Historical Affairs and Landmark Review Board

HALRB Case 14-30 (HP1400055)

A request by Theodore Schmitt & Rebecca Knotts, owners of 2315 North Kenmore Street in the Maywood Historic District, to raise the height of the existing side-gable roof and construct a two-story rear addition.

CERTIFICATE OF APPROPRIATENESS STAFF REPORT

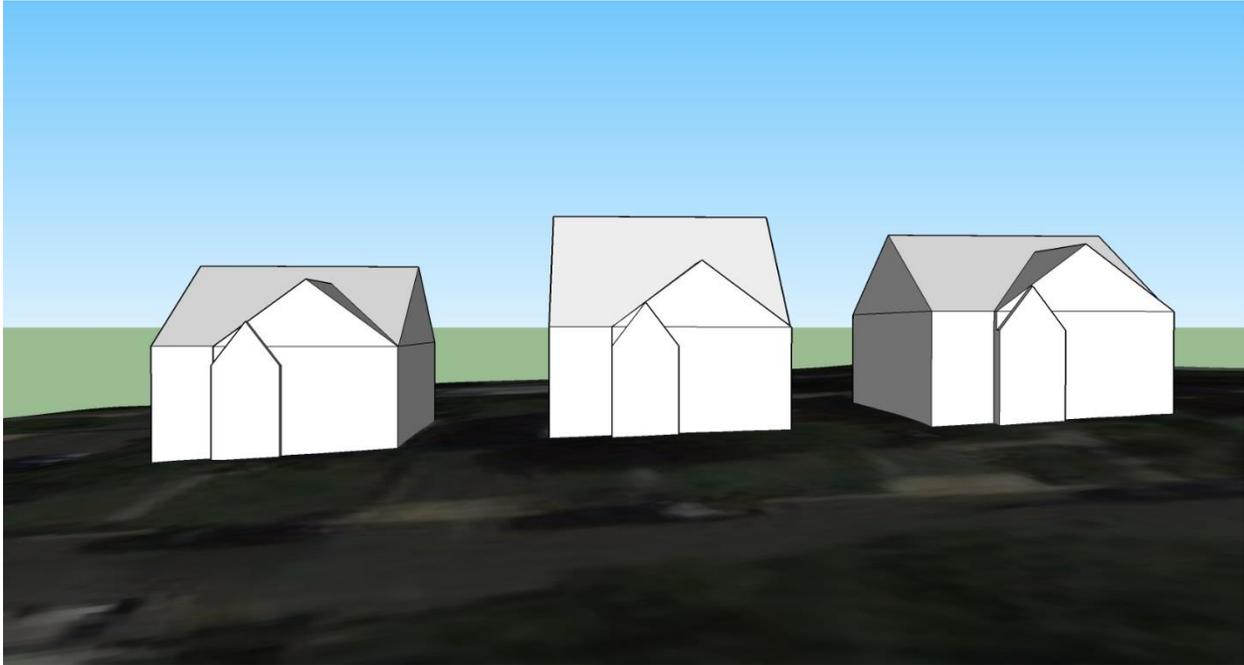
The applicants returned to DRC in December with updated plans. Staff shared a Sketch Up massing model (see below) that showed the proposed new roof height (4’ increase) in relation to the two adjacent matching buildings. The drawings illustrated that raising the roof would have minimal negative impact to the proportions of the facade or the streetscape due to the existing grade.
